July 17, 2013

RE: Baseline Data Report Amendment, Copper Flat Mine, Sierra County, New Mexico

Baseline Data Report Comments/Responses

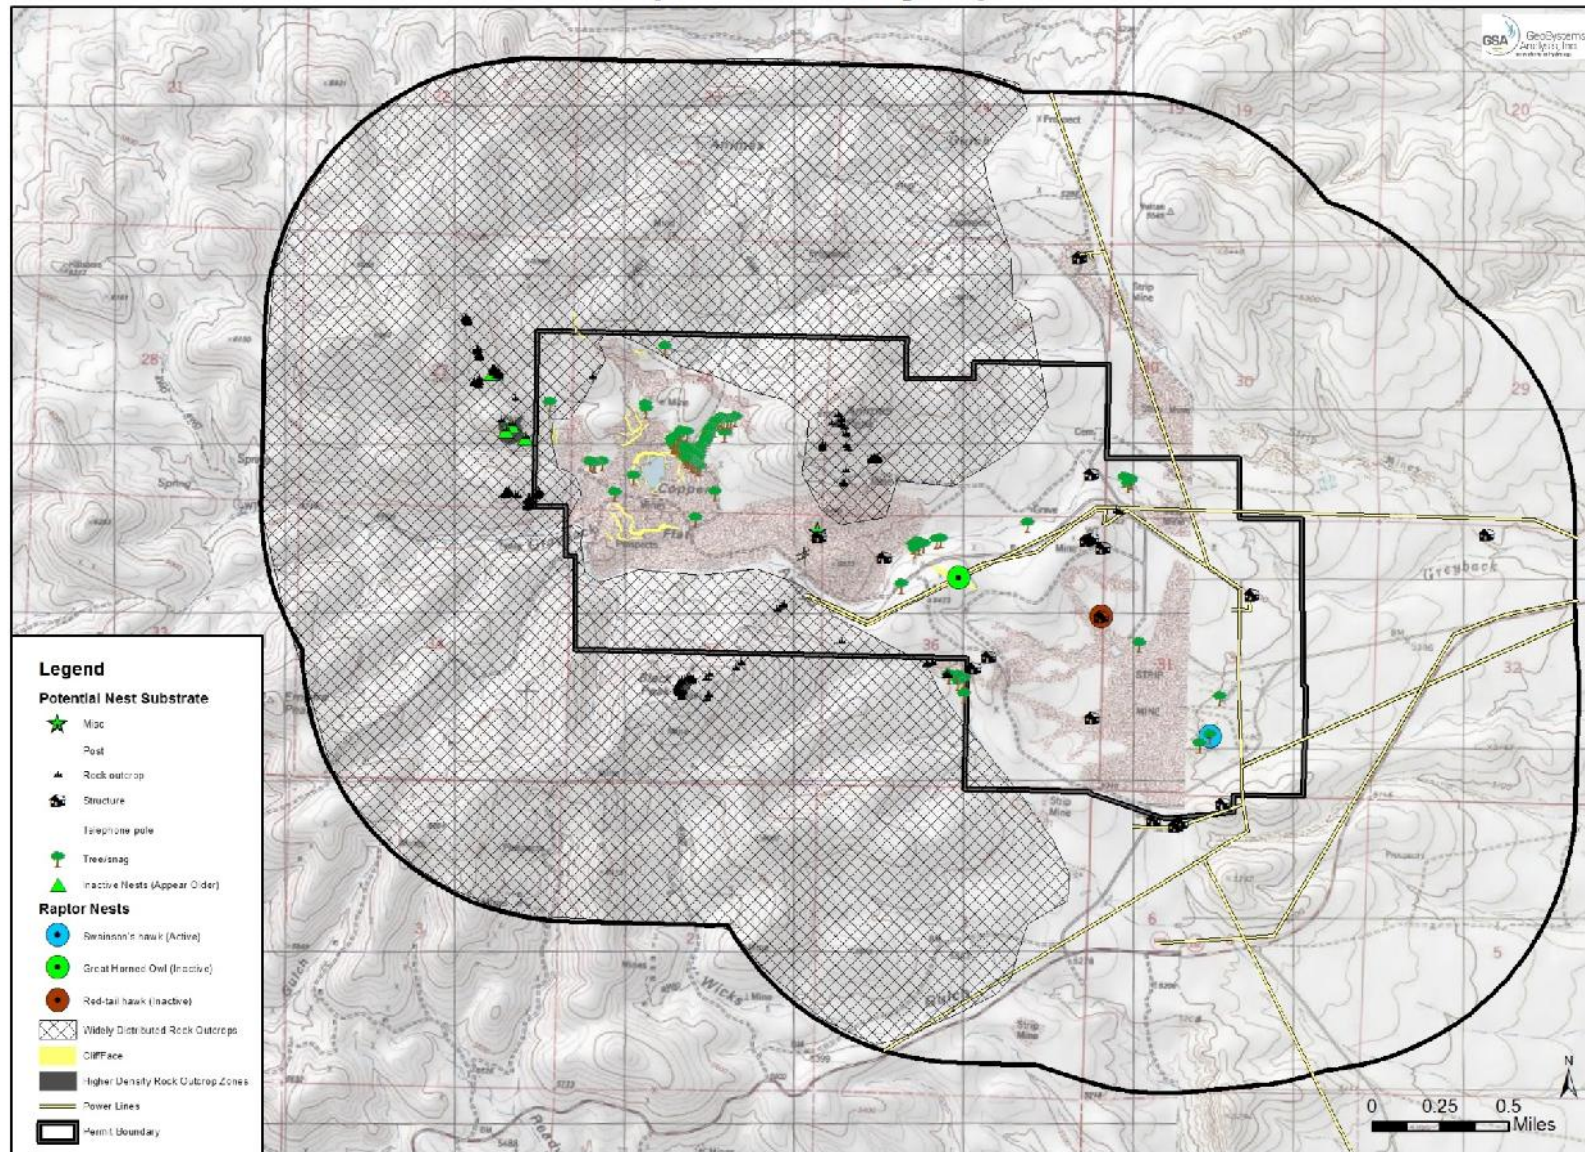
Comment 9. Please conduct a survey for raptor nests in all suitable habitat within one mile of any potential mine-related disturbance.

A raptor nest survey was completed during late-April through late-May 2013. Nests housing other birds of prey, such as owls, were also included in the survey. Potential nesting substrate including powerline poles, telephone poles, rock outcrops, large trees, snags, cliff faces, suitable structures, and towers were mapped during this effort while surveying was completed. Substrates with the highest probability for nesting were also resurveyed for the presence of nests during mid- to late-May. Raptor nests identified during the 2011 walking transects were revisited during the 2013 raptor nest survey to determine whether they were currently active since site fidelity is common in some raptor species.

A map showing suitable nesting substrate documented during field surveys is provided as Figure 5A-4. Towers still present from prior mining at Copper Flat are represented as structures on the map as are abandoned buildings. Areas with dense rock outcrop clusters are shown as either the individual surveyed rock outcrop (symbolized as a rocky point) or as a dark grey outline. When rock outcrops were observed to be more widely distributed, they are depicted with a cross-hatch on the map because individual outcrops were typically surveyed from the distance with binoculars and not always visited with a GPS. Trees and snags are both shown with the tree symbol on the map.

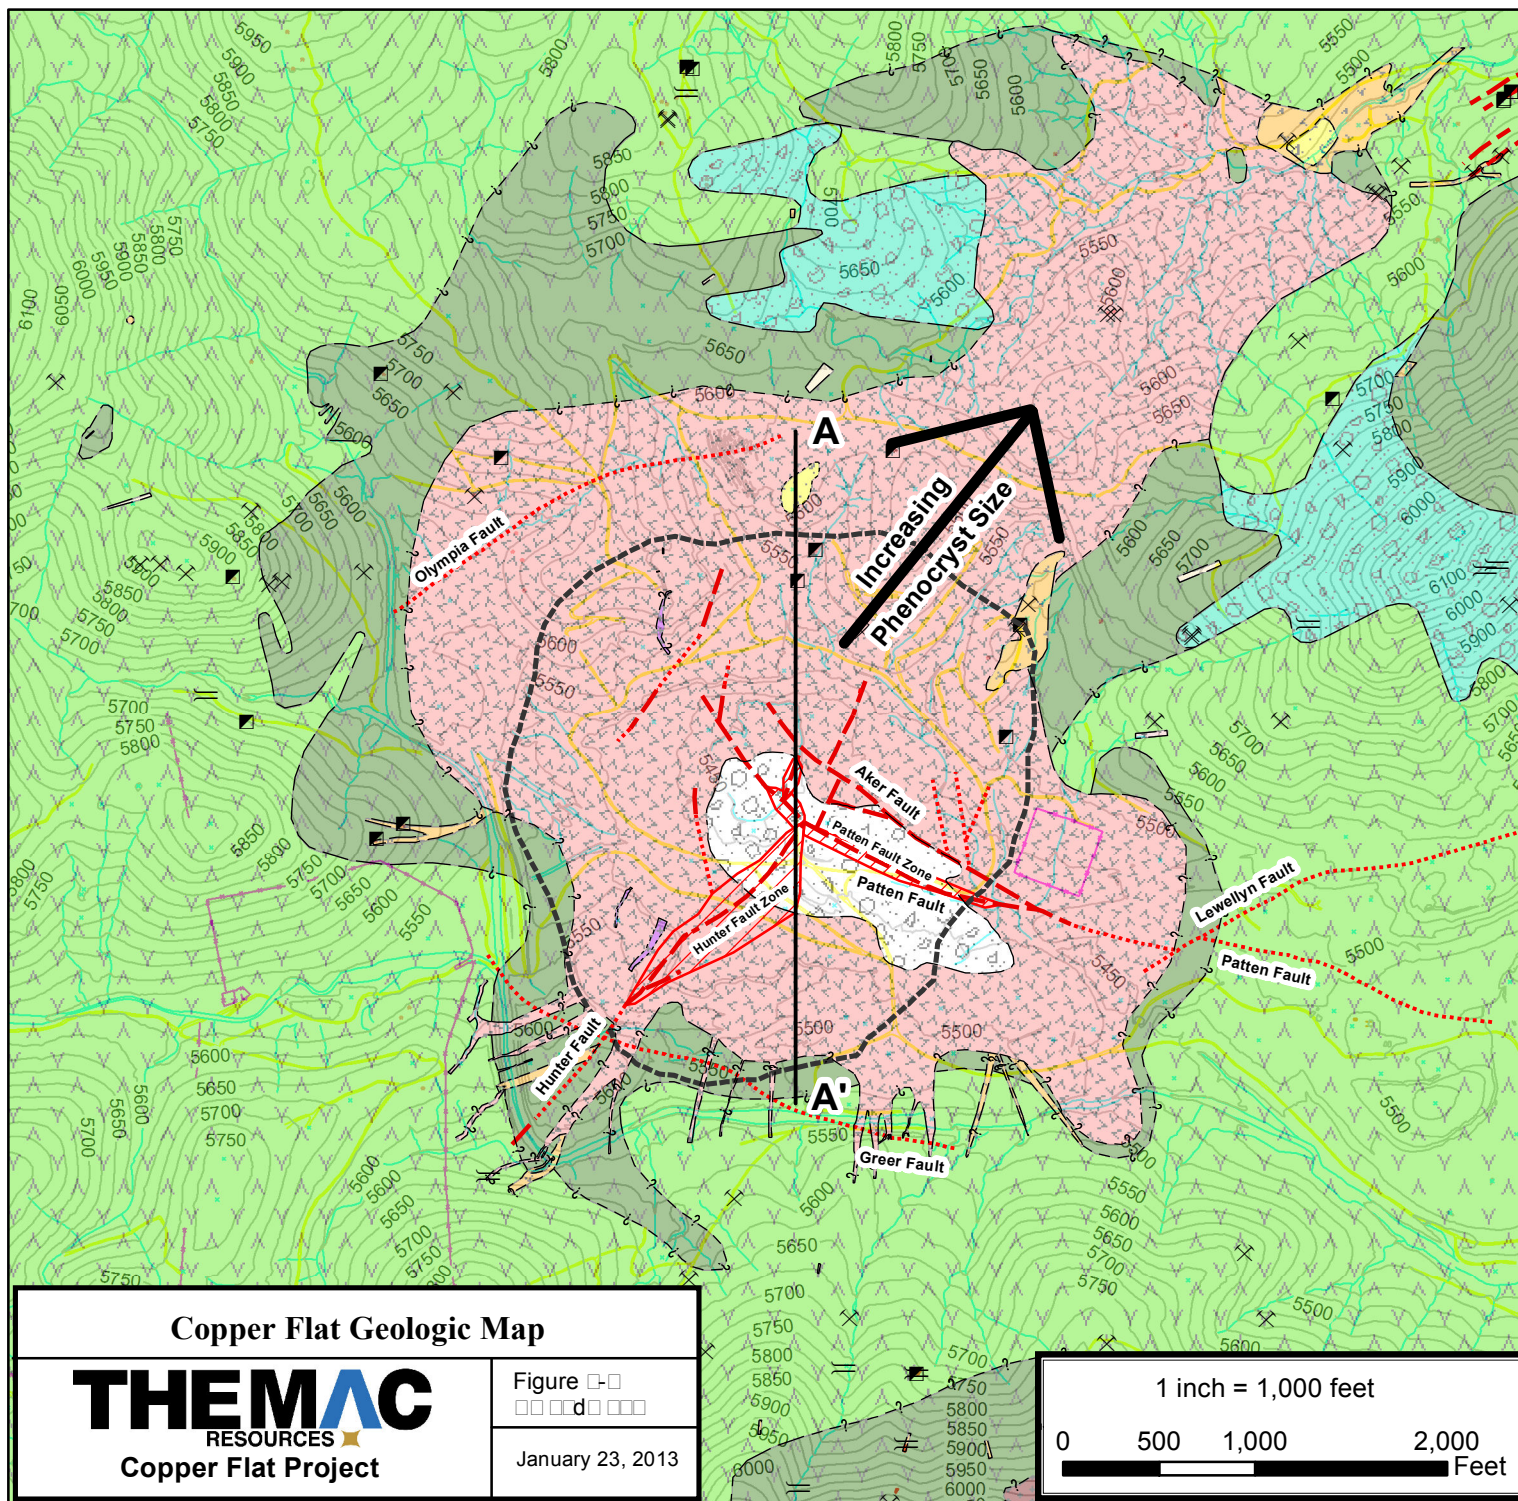
NMOSE #4/ NMCC #149 comment: "Figure 7.5. Add description of fault systems in legend beneath label for fault (e.g., Hunter fault system N20E, Patten Fault system N50W). Note that Section 8 figures have been labeled."

NMOSE #4/ NMCC #149 response: Figure 7-5 Amendment (attached) presents an updated Copper Flat Geologic Map with all faults labeled. Faults include Hunter fault/fault zone, Patten fault/fault zone, Aker fault, Olympia fault, Greer fault, and Lewellyn fault.

Three principal structural zones are present at Copper Flat and surrounding area, the most prominent of which is a northeast-striking fault that trends N 20°-40°E that includes the Hunter and parallel faults or the Hunter fault zone. In addition, west-northwest striking zones of structural weakness (N50°-70°W) are marked by the Patten, Aker, and Greer faults, and east-northeast striking zones are marked by the Olympia and Lewellyn faults. All faults have a near-vertical dip; the Hunter fault system dips 80°W, the Patten dips approximately 70°S-80°S, and both the Olympia and Lewellyn fault systems dip between 80°S and 90°S.

Figure 1. Aerial photograph showing the approximate locations of historical groundwater quality data points along Percha Creek, Sierra County, New Mexico.

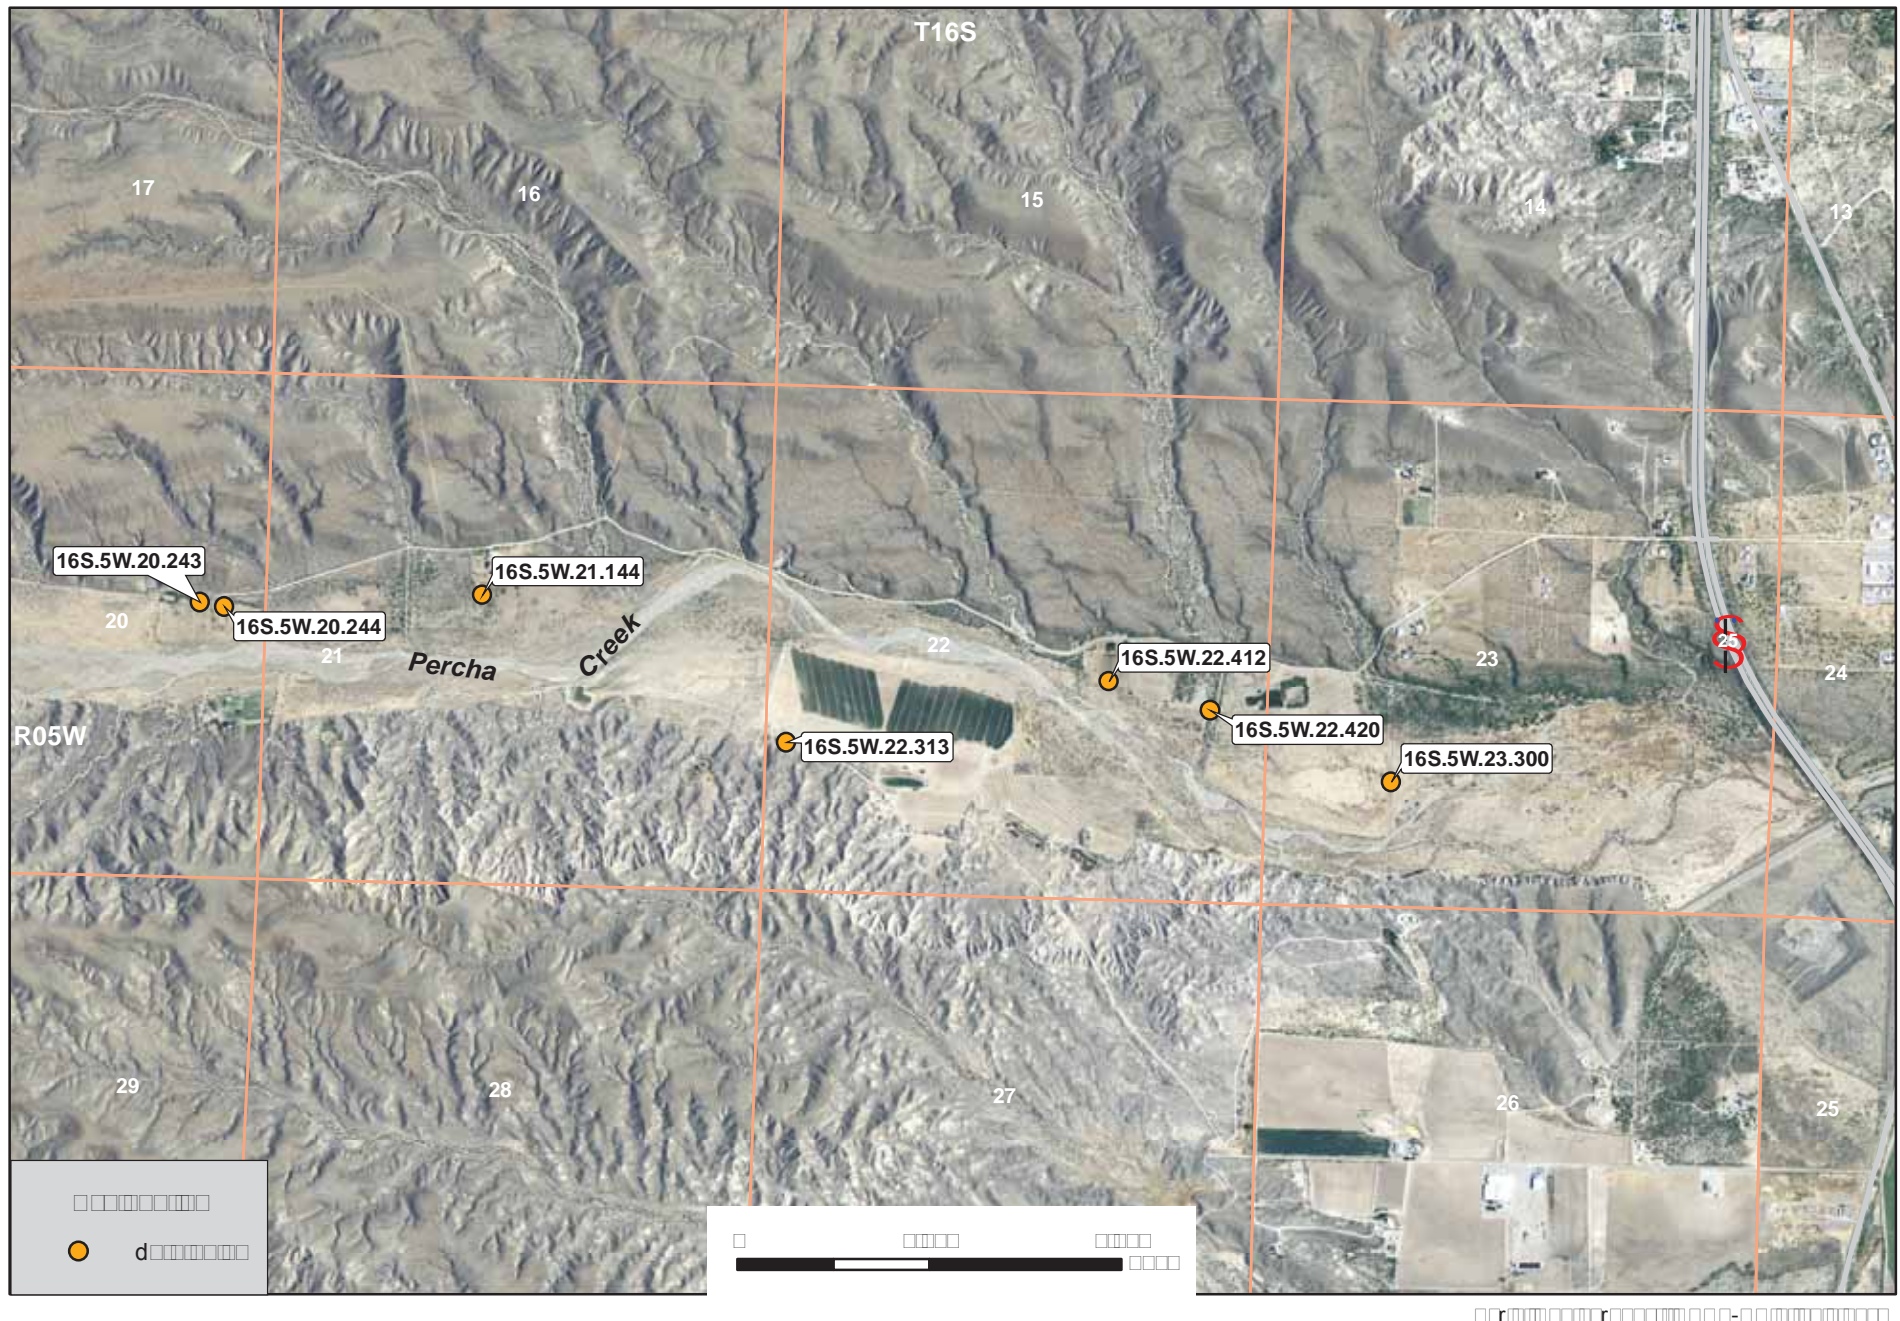
25	a. Percha Creek alluvium: Provide any historic or recent GW quality data for the alluvium.

- a. ☐ Percha Creek alluvium: Murray (1959) and Wilson et al. (1981) provide groundwater-quality data for wells completed along Percha Creek, presented in Table 1 and locations are shown on Figure 1. Several wells are described as being completed in Quaternary-age sand (Murray, 1959), and several wells are described as being completed in the Santa Fe Group (Wilson et al., 1981). Wilson et al. (1981) do not identify any wells completed in Quaternary-age alluvium along Percha Creek. The Copper Flat BDR Section 8.2.4.3 states “Logs from wells drilled along Las Animas and Percha Creeks indicate that upper alluvial gravels extend from the surface to a depth of approximately 20 to 60 ft...,” whereas the wells presented in Table 1 below are completed to depths of 154 to 265 ft. The wells identified along Percha Creek in BDR Figure 8-21 and the artesian wells identified in BDR Appendix 8-H are completed in the Santa Fe Group. BDR Figure 8-12 indicates that the alluvial aquifer along Percha Creek only extends from Caballo Reservoir to about 3 miles west of the Reservoir, and there are no known water-quality data from the Percha Creek alluvium.
